## Service Bulletin

No. : MZ05-018

**Model:** ER2500

**Subject:** Software Update

**FRONT END Version** →

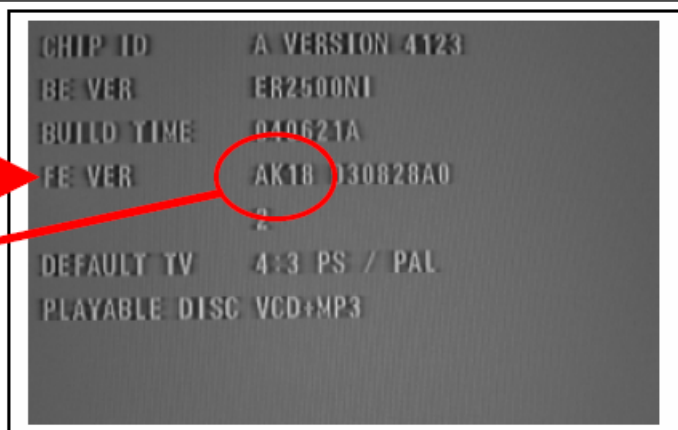
**Symptom:** 1. Improvement of readability for low reflection DVD discs.  
2. Improvement of Actuator Noise.  
2-1) If an MP3 disc is made using a Windows XP® PC when playing the disc back, Actuator Noise occurs.

1. Press the **POWER ON/STANDBY** button to turn on the unit.
2. Press the **OPEN/CLOSE** button to open the tray.
3. Press the **CLR, 2, 5, 8, 0** and **CLR** button in order on the remote controller.
4. The following information is displayed on the TV screen. The firmware version is shown.
5. Press the **POWER ON/STANDBY** button to quit **SERVICE MODE**.

**Solution:** Update the FRONT END software (firmware) version to AK22.  
Before you update, please check the firmware version. Refer to page 6 of the ER2500 Service Manual for the procedure.

**AK22** ←
